**TOWN OF NEWBURGH  
PLANNING BOARD  
REVIEW COMMENTS**

<b>PROJECT:</b>	<b>WEBB PROPERTIES</b>
<b>PROJECT NO.:</b>	<b>14-10</b>
<b>PROJECT LOCATION:</b>	<b>SECTION 97, BLOCK 2, LOTS 35 &amp; 43</b>
<b>PROJECT REPRESENTATIVE:</b>	<b>A. DIACHISHIN &amp; ASSOCIATES</b>
<b>REVIEW DATE:</b>	<b>30 JULY 2014</b>
<b>MEETING DATE:</b>	<b>7 AUGUST 2014</b>

Re: Site Plan and Lot Line Revision for Webb Properties, Inc., Town of Newburgh  
Planning Board **Project Number 2014-10.**

*Lot Coverage Calculations  
 Site Plan  
 for  
 Webb Properties, Inc.*

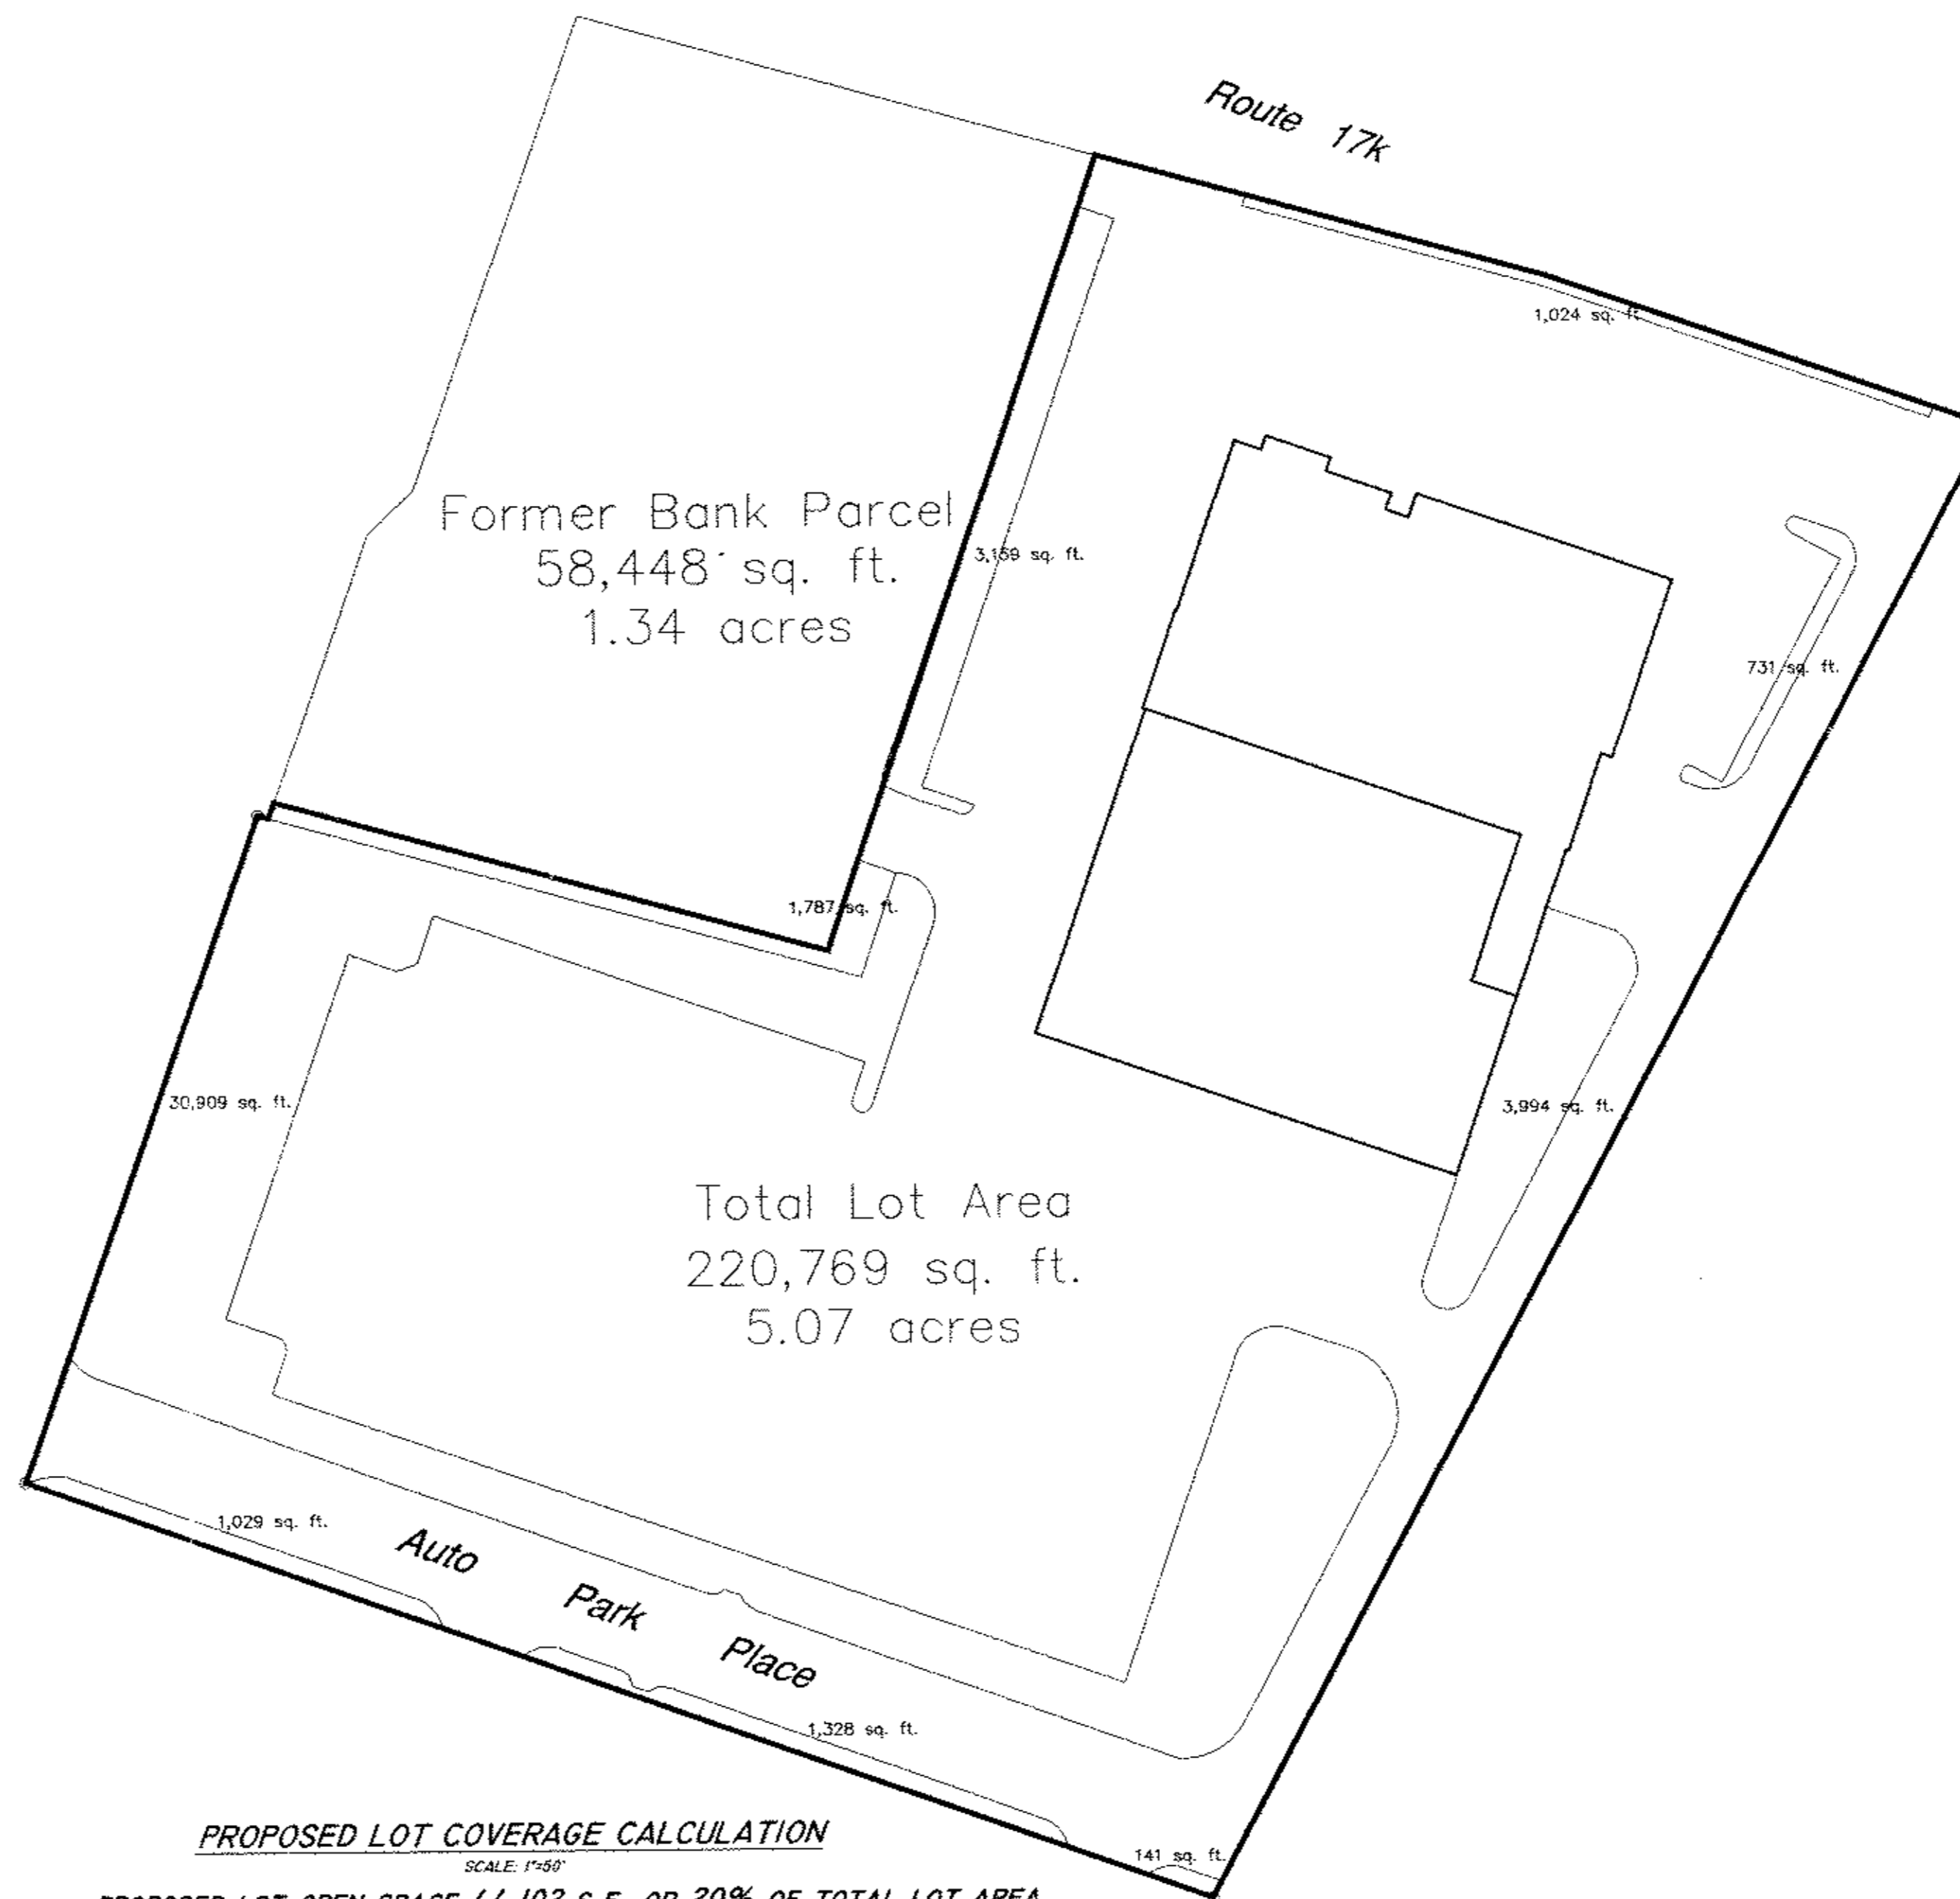
- i. A plan (sheet 4 of 4) has been provided to show lot coverage calculations (MH&E comment #7). The property lines have been adjusted since the May submission to make the 80% coverage calculation work on the new dealership lot.
